**Town of Kittery  
Planning Board Meeting  
November 16 2023**

**ITEM 5—17 and 25 US Route 236—Major Site Plan — Preliminary Review**

**RE: Town of Kittery, Planning Board Services  
Major Site Plan Review – Preliminary Review  
Rooming House Redevelopment, 17 & 25 Route 236, Tax Map 20, Lot 12 and Tax Map 21, Lot 20  
CMA #591.165**

<b>TO:</b>	CMA Engineers- Jodie Bray Strickland, PE	<b>FROM:</b>	Geoffrey R. Aleva, PE	<b>DATE:</b>	11/2/2023
<b>SUBJECT:</b>	Major Site Plan Review – Preliminary Review				
<b>PROJECT:</b>	Rooming House Redevelopment, 17 & 25 Route 236, Tax Map 20, Lot 12 and Tax Map 21, Lot 20 C.C. Project # 2218000

**ENLARGED SITE PLAN**

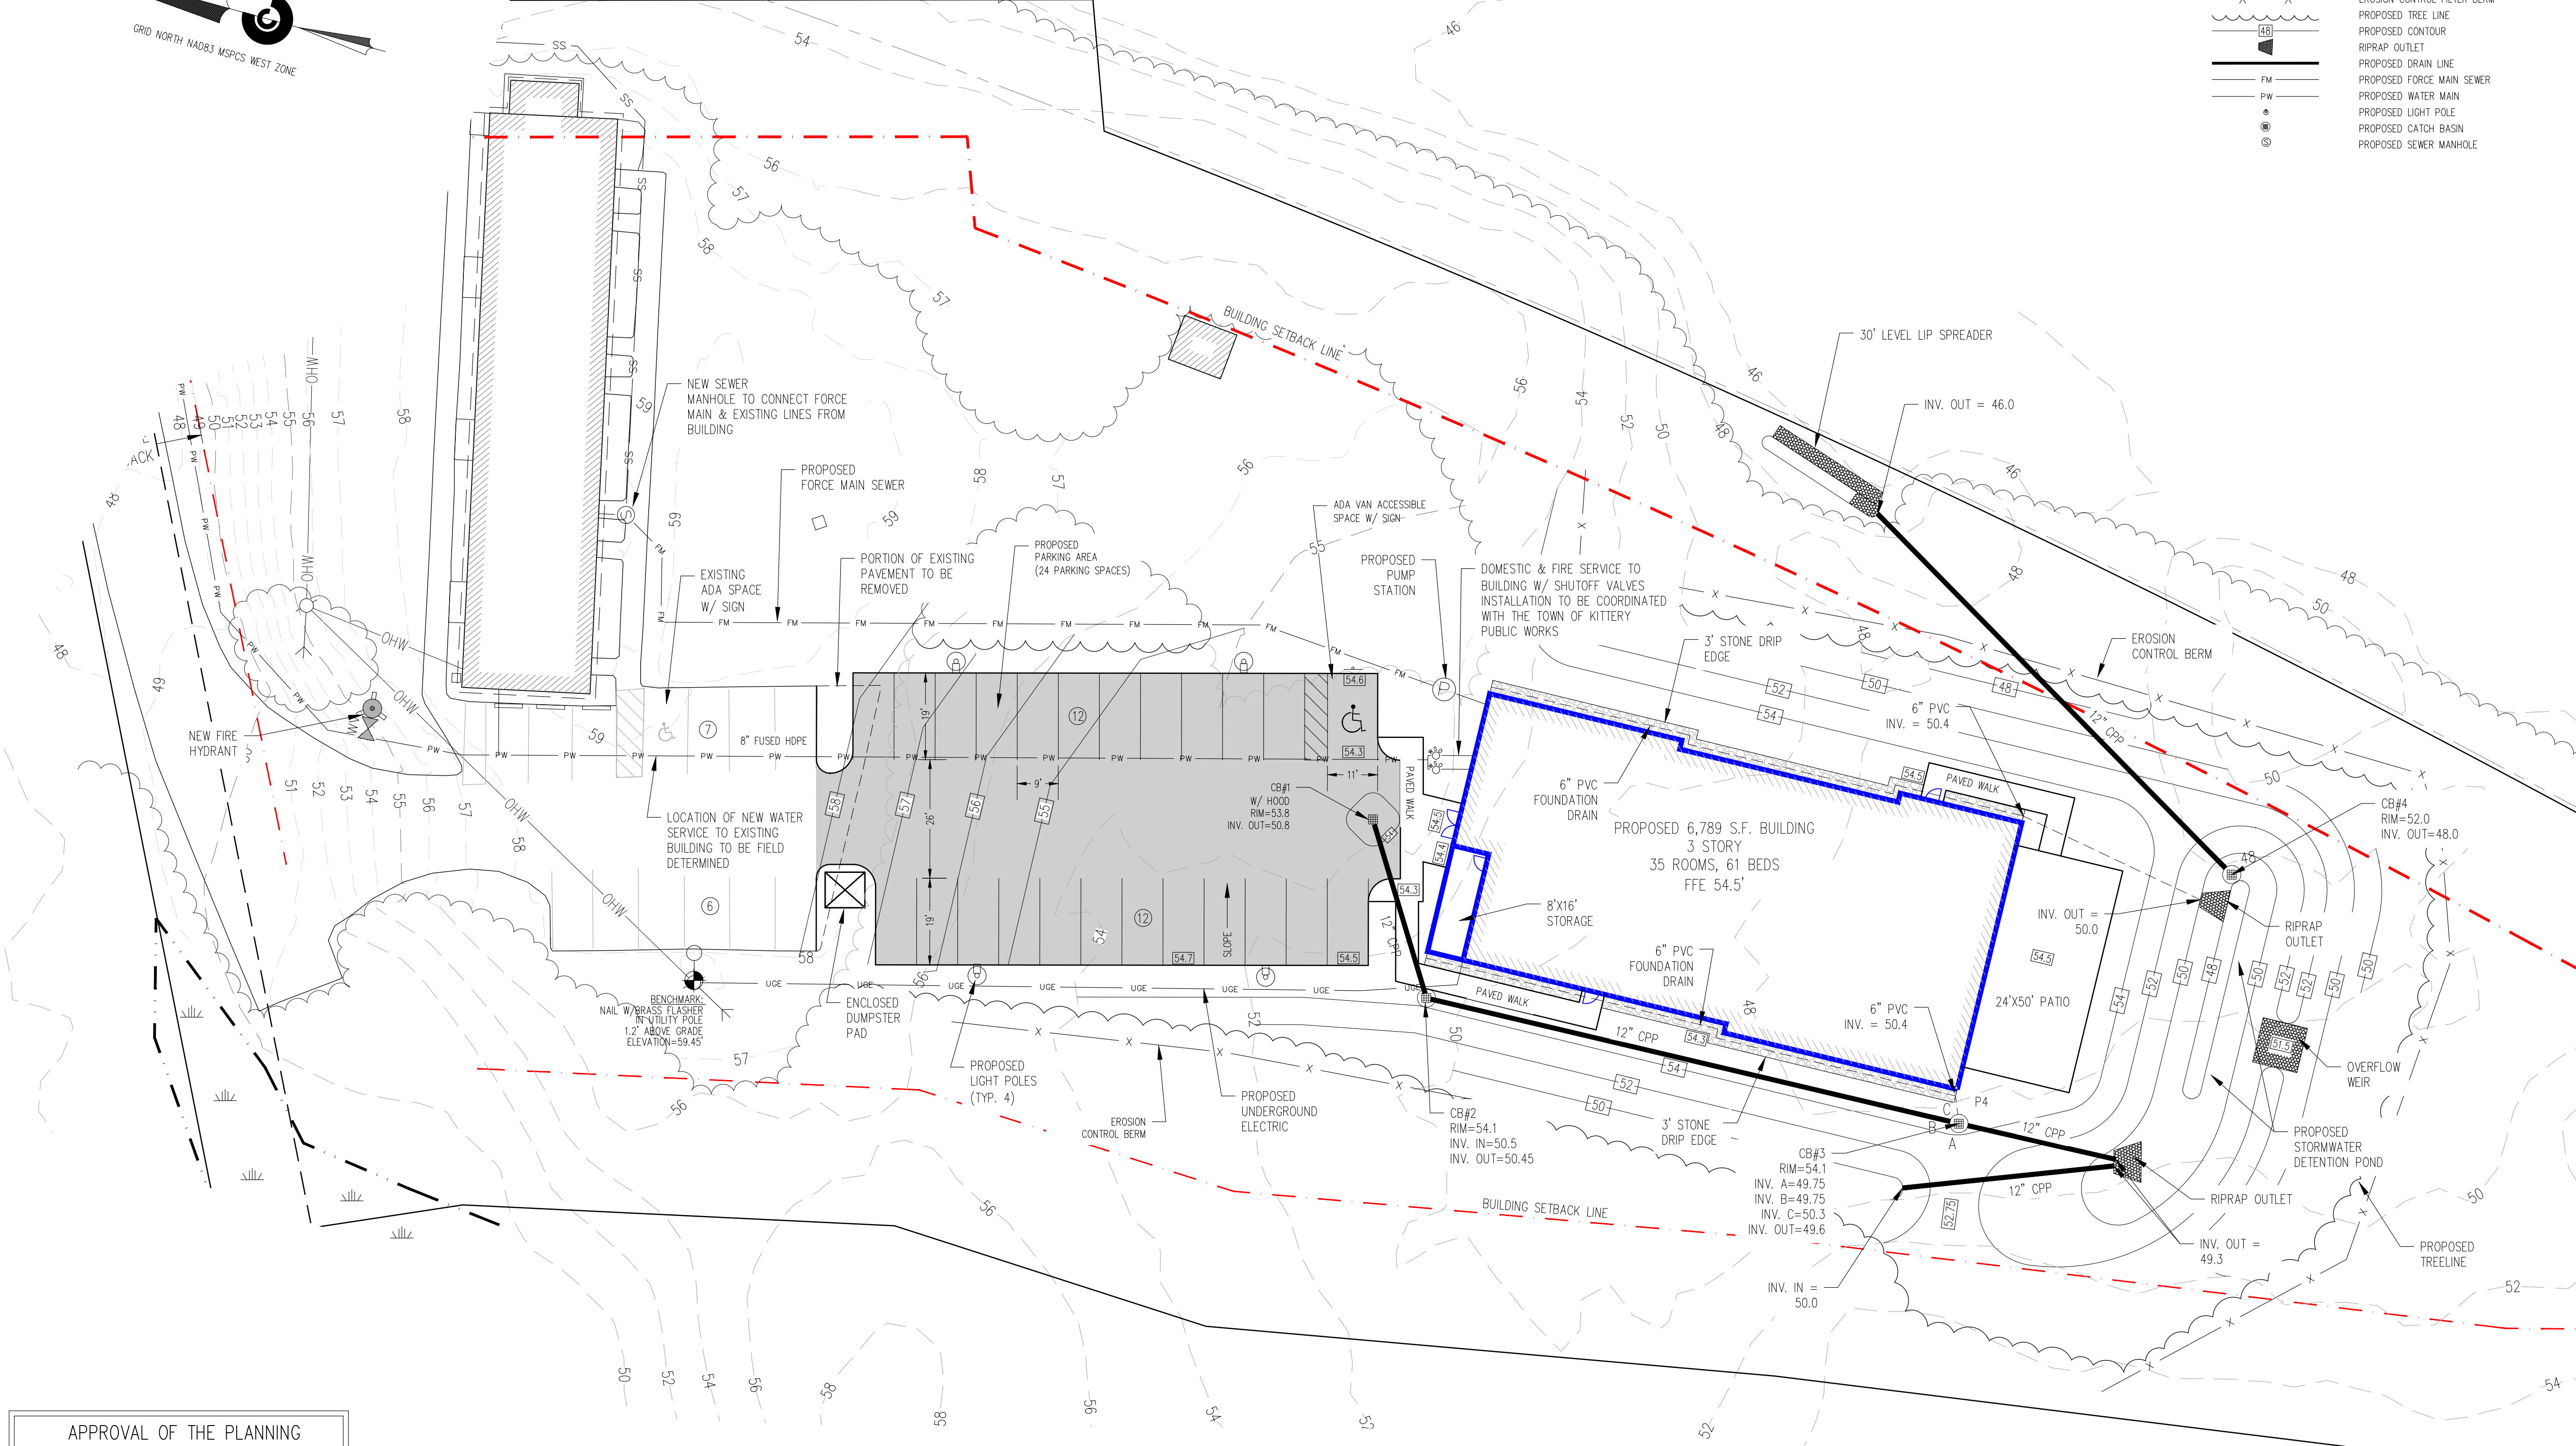
Sheet L1-Proposed Site Plan:

1. The Scope of Work indicates that project will "...result in the construction of over 5,000 of gross **nonresidential** floor area..."
2. The plan shows, and the scope of work states, that there are 35 rooms, 61 beds and 12 rooms per floor. This is in conflict with the 11 rooms per floor, 33 rooms and 57 beds discussed in the project narrative.

3. The plan shows 24 additional spaces but 22 are described in the project narrative.
4. The Proposed Parking Spaces Table indicates that there are 14 existing spaces and 23 proposed but the plan shows 13 existing and 24 proposed.

5. The 1 space per 3 beds, 21 spaces required in the Proposed Parking Spaces table does not have data to support the assumption.
6. In the Proposed Coverage Info table, the existing pavement amount decreases. The area that is to be removed should be shown on the plan.

7. In the Proposed Coverage Info table, the proposed dripline filter is included in the impervious calculation.
8. There are items/linetypes on the plan that should be defined in the legend.

9. The pipe sizes and materials should be called out on the plan.
10. There are multiple symbols used for catch basins.
11. The dumpster pad needs to be enclosed.

12. The existing ADA space should have a sign.
13. Areas of pavement and concrete should be called out on the plan.
14. Is there a significance to the colored lines? If so, these should be explained in the legend.

21. The sawcut lines to install the proposed 15" HPE culvert at the intersection with Route 236 and the water main connection should be shown.
22. Existing utility information – size, material, inverts, etc. should be shown on the plan.

23. The proposed inert out of the 15" HDPE culvert at the intersection with Route 236 should be field verified and indicated on the plan.
24. There are P numbers for the piping (P1, P2, etc.) but there is no table or notes that explain the designation.

<b><u>Site Plan Comments</u></b>	
We have the following comments with respect to the site plans.	
<p>Sheet L1-Proposed Site Plan:</p> <ol style="list-style-type: none"> <li>1. The Scope of Work indicates that project will "...result in the construction of over 5,000 of gross nonresidential floor area..."</li> <li>2. The plan shows, and the scope of work states, that there are 35 rooms, 61 beds and 12 rooms per floor. This is in conflict with the 11 rooms per floor, 33 rooms and 57 beds discussed in the project narrative.</li> <li>3. The plan shows 24 additional spaces but 22 are described in the project narrative.</li> <li>4. The Proposed Parking Spaces Table indicates that there are 14 existing spaces and 23 proposed but the plan shows 13 existing and 24 proposed.</li> <li>5. The 1 space per 3 beds, 21 spaces required in the Proposed Parking Spaces table does not have data to support the assumption.</li> <li>6. In the Proposed Coverage Info table, the existing pavement amount decreases. The area that is to be removed should be shown on the plan.</li> <li>7. In the Proposed Coverage Info table, the proposed dripline filter is included in the impervious calculation.</li> <li>8. There are items/linetypes on the plan that should be defined in the legend.</li> <li>9. The pipe sizes and materials should be called out on the plan.</li> <li>10. There are multiple symbols used for catch basins.</li> <li>11. The dumpster pad needs to be enclosed.</li> <li>12. The existing ADA space should have a sign.</li> <li>13. Areas of pavement and concrete should be called out on the plan.</li> <li>14. Is there a significance to the colored lines? If so, these should be explained in the legend.</li> <li>15. The size and material of the sewer force main should be called out.</li> <li>16. The size and material of the water should be called out.</li> <li>17. The water main and services should have gate valve and shutoff.</li> </ol>	<p><i>The plans have been updated to address the proposed conditions and address the review comments.</i></p> <ol style="list-style-type: none"> <li>1. <i>No response required.</i></li> <li>2. <i>The plans correctly indicate the room count.</i></li> <li>3. <i>The plan correctly indicates the parking spaces.</i></li> <li>4. <i>The table has been updated on the plans.</i></li> <li>5. <i>The data used to support this assumption is from information from the property owner who is developing this for this type of worker.</i></li> <li>6. <i>Slight change in existing pavement is the small removal of pavement along the connection to the new work.</i></li> <li>7. <i>No change proposed.</i></li> <li>8. <i>The plans have been updated</i></li> <li>9. <i>The plans have been updated to indicate the pipe sizes.</i></li> <li>10. <i>The symbols have been simplified.</i></li> <li>11. <i>Plans indicate it is enclosed with detail on fencing shown on Sheet L3.</i></li> </ol>

<ol style="list-style-type: none"> <li>18. The proposed stormwater pond to the south of the building should be labeled.</li> <li>19. Profiles of the water and sewer mains should be provided.</li> <li>20. Where does the piping for the 3' stone drip edge on the east side of the building outlet?</li> <li>21. The sawcut lines to install the proposed 15" HPE culvert at the intersection with Route 236 and the water main connection should be shown.</li> <li>22. Existing utility information – size, material, inverts, etc. should be shown on the plan.</li> <li>23. The proposed invert out of the 15" HDPE culvert at the intersection with Route 236 should be field verified and indicated on the plan.</li> <li>24. There are P numbers for the piping (P1, P2, etc.) but there is no table or notes that explain the designation.</li> </ol>	<ol style="list-style-type: none"> <li>12. <i>The existing ADA space has been noted with a sign.</i></li> <li>13. <i>Pavement has been indicated on the plan.</i></li> <li>14. <i>The colored line is the building setback line and has been noted on the plan.</i></li> <li>15. <i>The force main will size will be determined when the pump station is designed.</i></li> <li>16. <i>The water line size has been indicated. It will be verified during the building design.</i></li> <li>17. <i>Water gate valve and shutoff valves will be determined and coordinated with Kittery Water District.</i></li> <li>18. <i>Stormwater pond has been labeled</i></li> <li>19. <i>We do not feel that profiles are needs for this work. The site utilities will be coordinated with the property town department.</i></li> <li>20. <i>Foundation drains and pipe outlets have been shown.</i></li> <li>21. <i>The sawcut line has been indicated.</i></li> <li>22. <i>Drain line pipe sizes have been shown. Existing sewer service size is unknown.</i></li> <li>23. <i>The new 15" HDPE will replace the existing 12" CMP. Inverts have been indicated.</i></li> <li>24. <i>P designations have been removed and the drain line pipe sizes have been added.</i></li> </ol>
